TECHNICAL NOTE

Job Name: One Horton Heath, The Holme and Homestal Reserved Matters Application
Job No: 332612639
Note No: STA-ZZ-XX-TN-T-0003
Date: 10th March 2026
Prepared By: Thea Harland
Reviewed By: Joe House
Subject: **Response to Hampshire County Council Highways Comments for RM/25/100615 At Land West of Burnetts Lane (The Holme and Homestal) dated 29.01.2026**

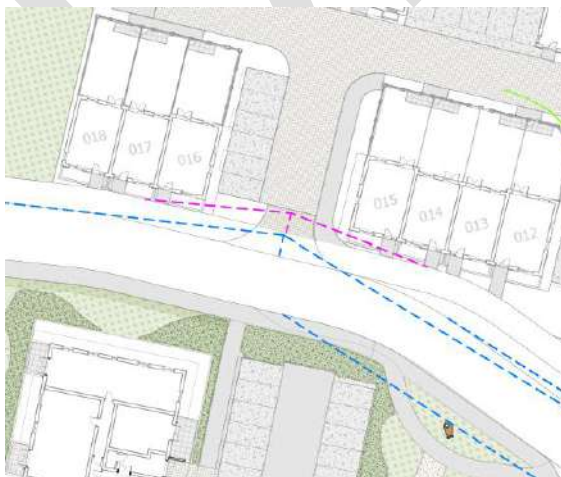
- 4.4. **HCC Comment (pg 10):** *"It would ... be requested that confirmation of raised tables across junctions for pedestrians and cyclists is however gained, as what appear to be the location of tables does not appear to directly link up with the foot/cycleways, as per the example below where a section of grass blocks direct progress. If this is the case, then they should be amended to provide a continuous link accordingly."*

The proposed side road crossing is located at the junction bellmouth adjacent to the SID Road and is not set back from the junction. The change in paving material shown on the submitted proposals does not indicate the location of the crossing. Instead, it represents a threshold paving treatment, which is proposed to signify the transition into a different road hierarchy and street environment. This has been shown in the extract shown and formally illustrated on the revised visibility splay drawing submitted and contained in **Appendix E**.
